Access Compliance Report

Public Rights-of-Way

(Pedestrian Signals)

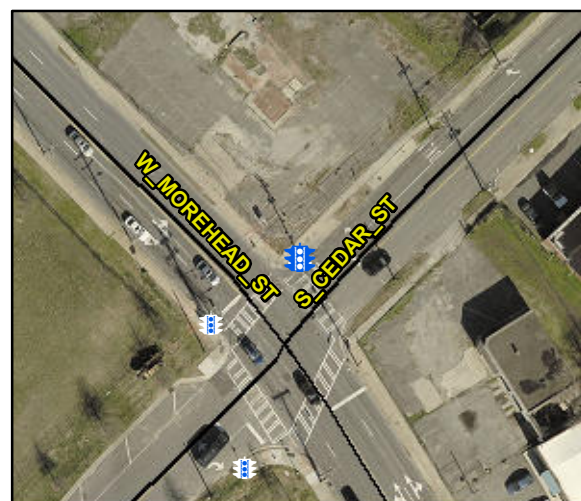
Intersection ID: N/A	Main Street:	Cross Street: N/A	Location: N/A
ADA ID: 791ECA7A151F	Signal Type: One Push Button-Non APS	Overall Compliance: No	Severity Score: BTN 1: N/A BTN 2: N/A No BTN: N/A
Codes/Mitigation Info/Possible Solution		Field Measurements/Component Compliance

PROW/ADA: R404.2

Possible Solutions: Remove and Replace Clear Space.
